RE: Whitewood Creek Restoration, Deadwood SD
Sites 1C, 2A, 2B, 3A, & 3B
Cost Proposal #05 – Proposal Request No. 5 (January 23, 2024)

REQUEST FOR PROPOSAL

Whitewood Creek Restoration – BP #1

PROPOSAL REQUEST NO: 5

WHITEWOOD CREEK RESTORATION
PROPOSAL REQUEST #5
ATTACHMENT #2.

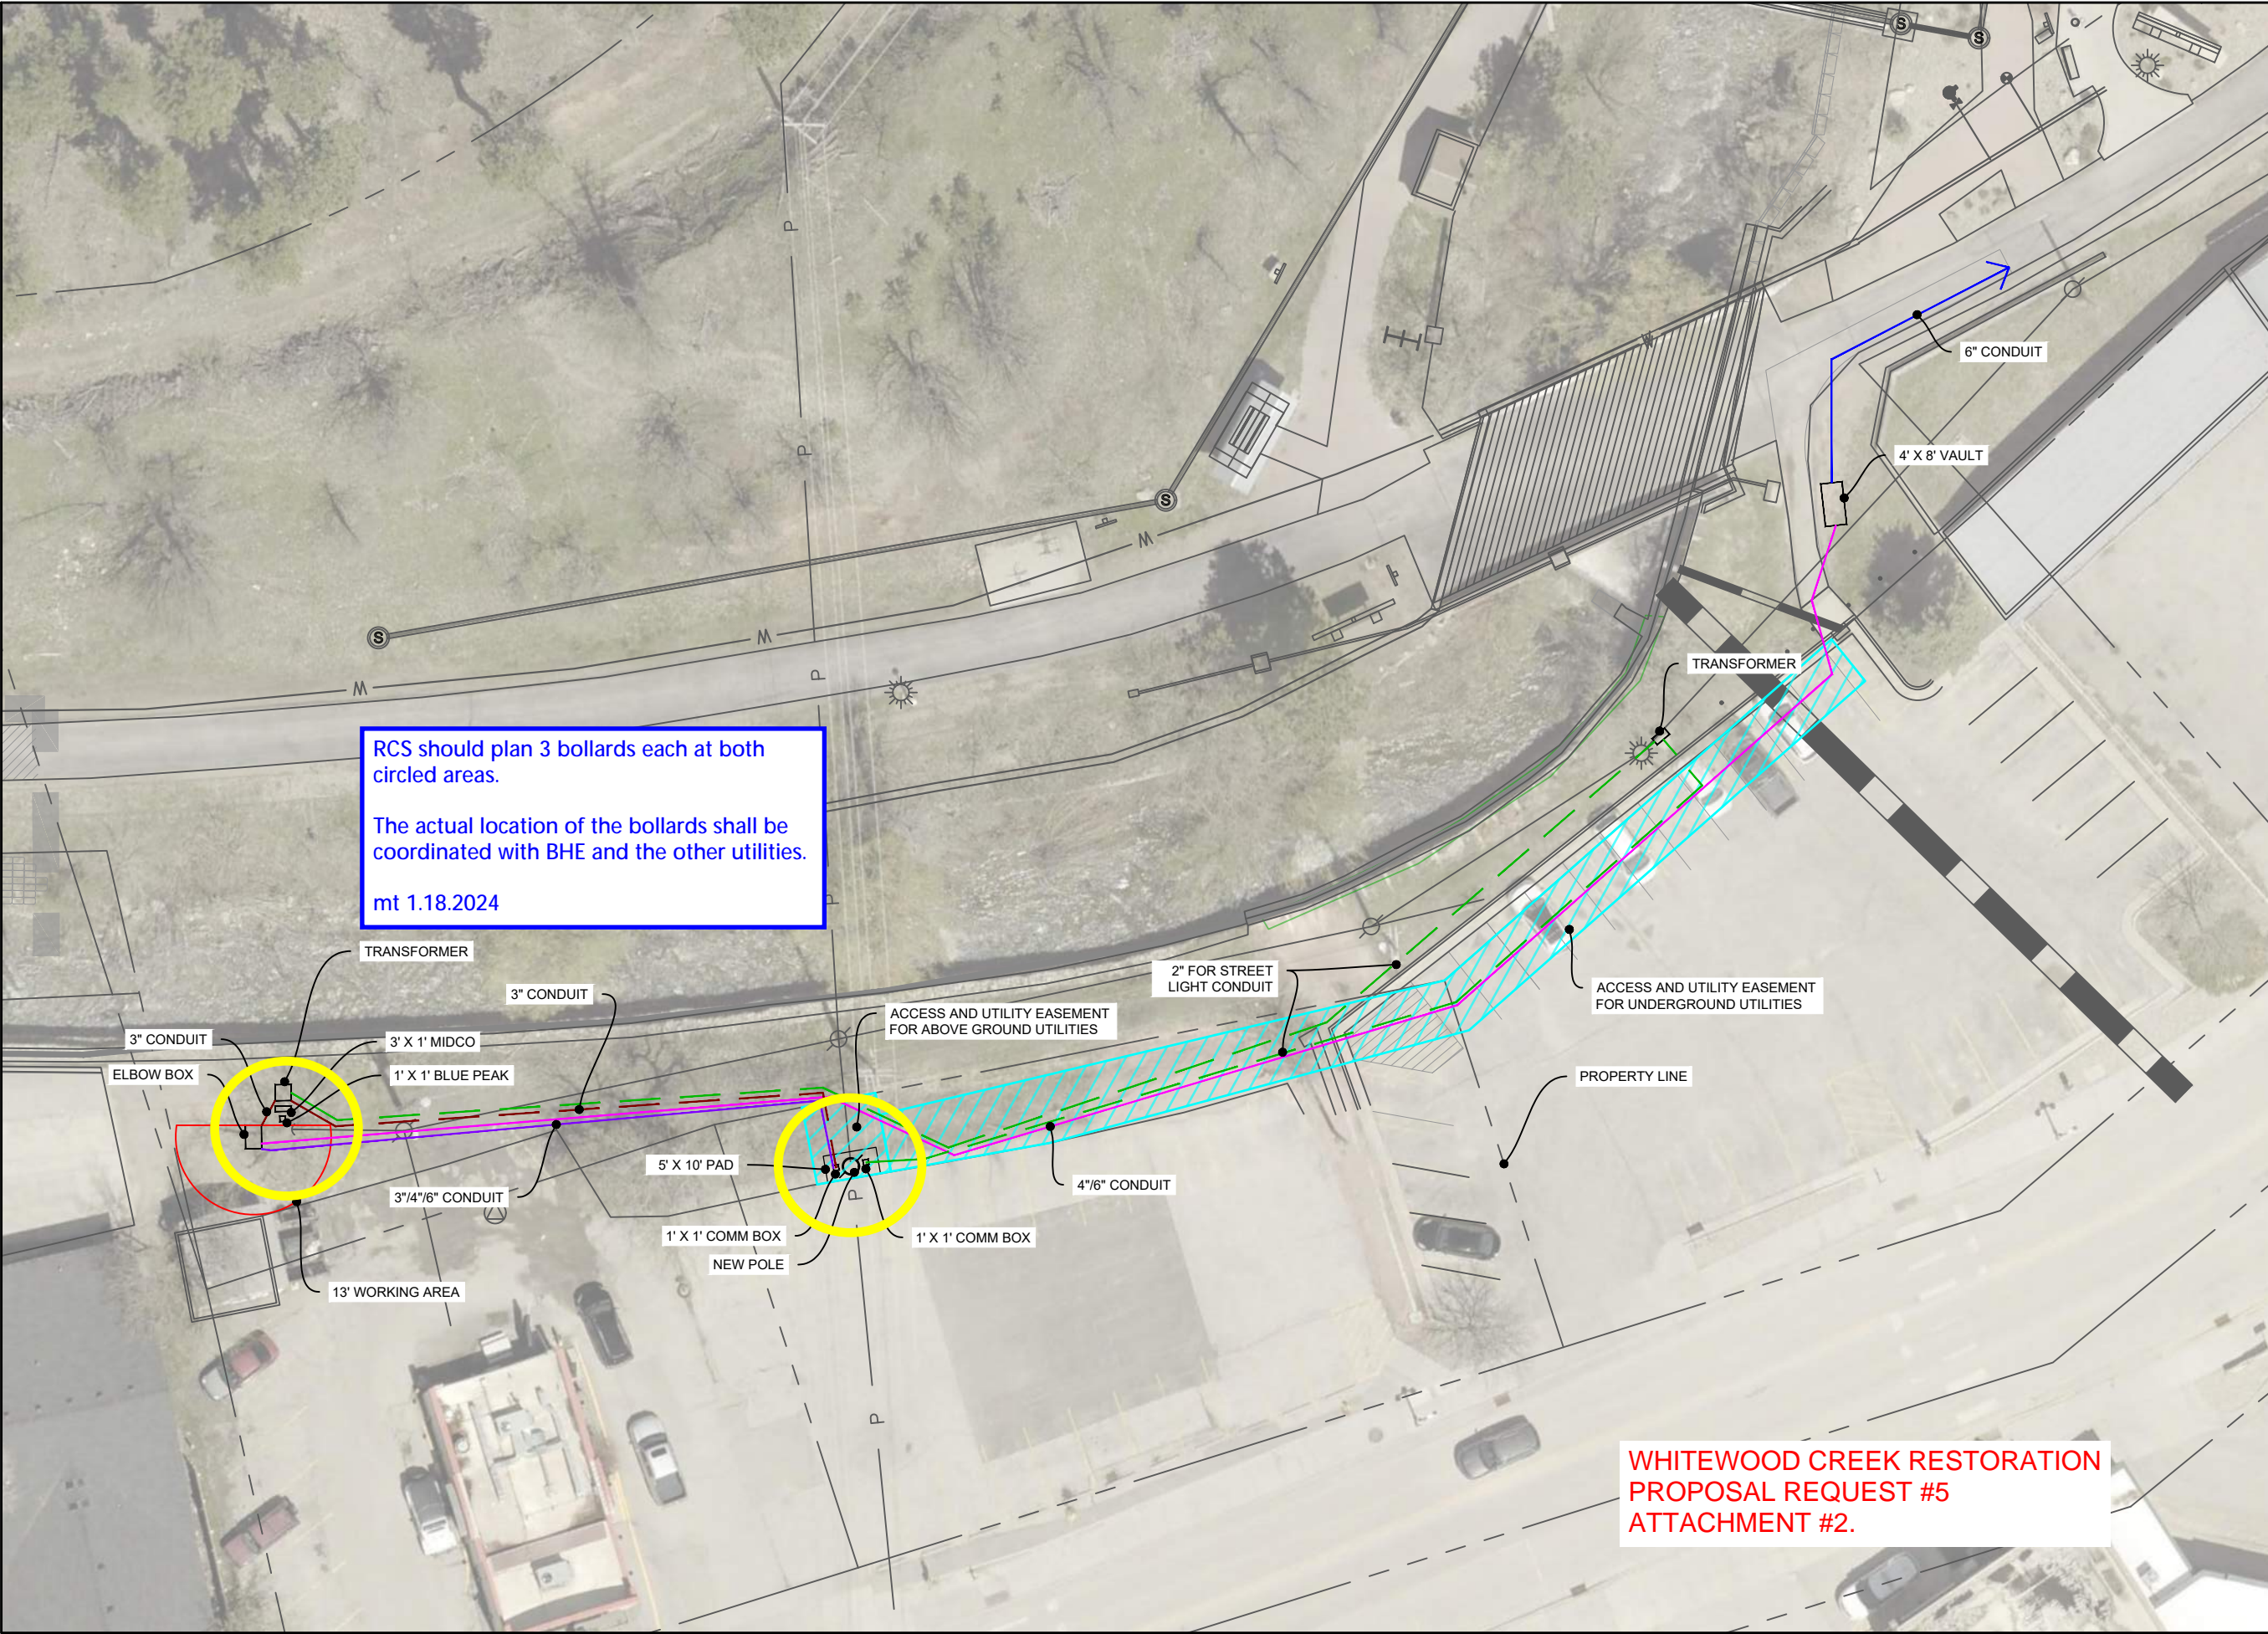
RCS should plan 3 bollards each at both circled areas.
The actual location of the bollards shall be coordinated with BHE and the other utilities.
mt 1.18.2024

**WHITEWOOD CREEK RESTORATION
PROPOSAL REQUEST #5
ATTACHMENT #3.**

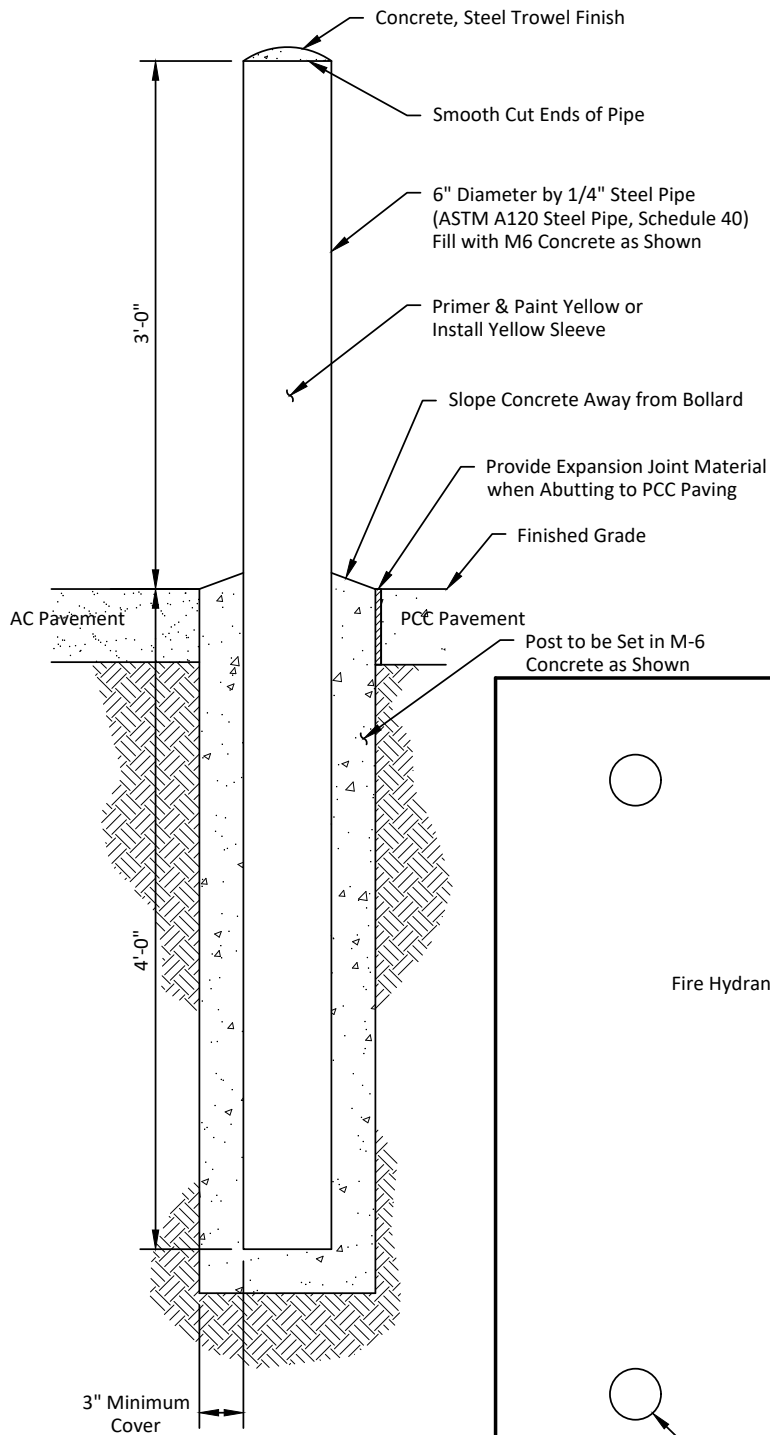
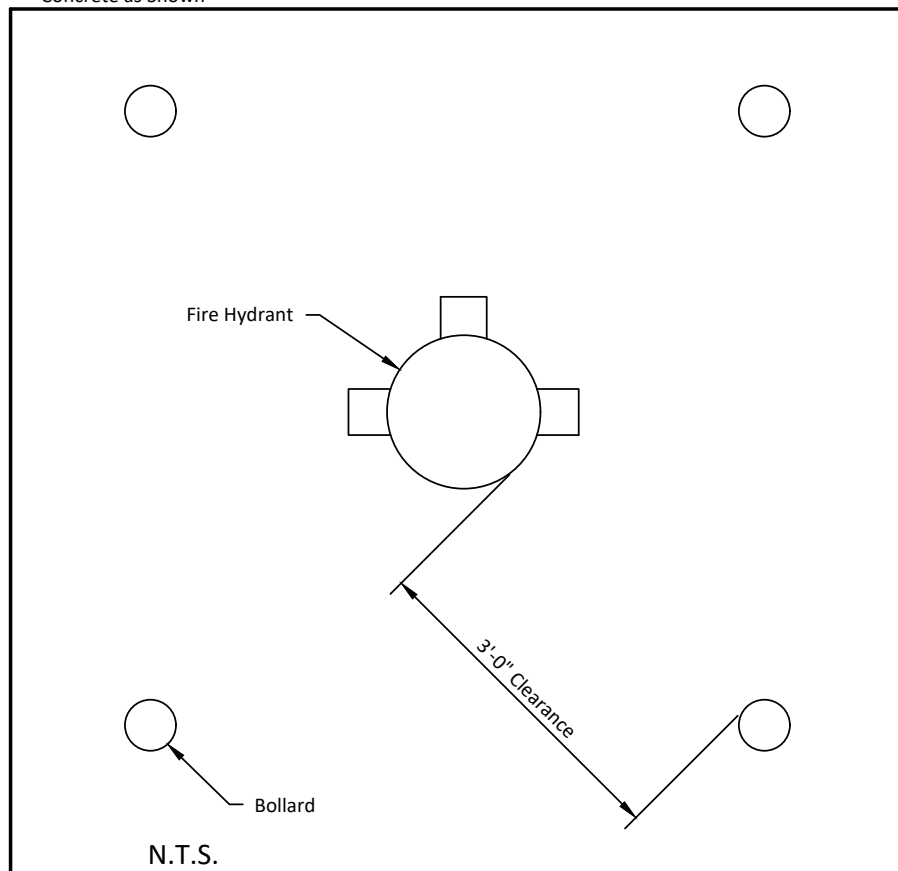
4. Replace the 4 existing bollards at the back of Monument's parking lot with 4 6x6 rail posts. Provide (2) horizontal 2x6 rails between the posts. (See Attachment #4).
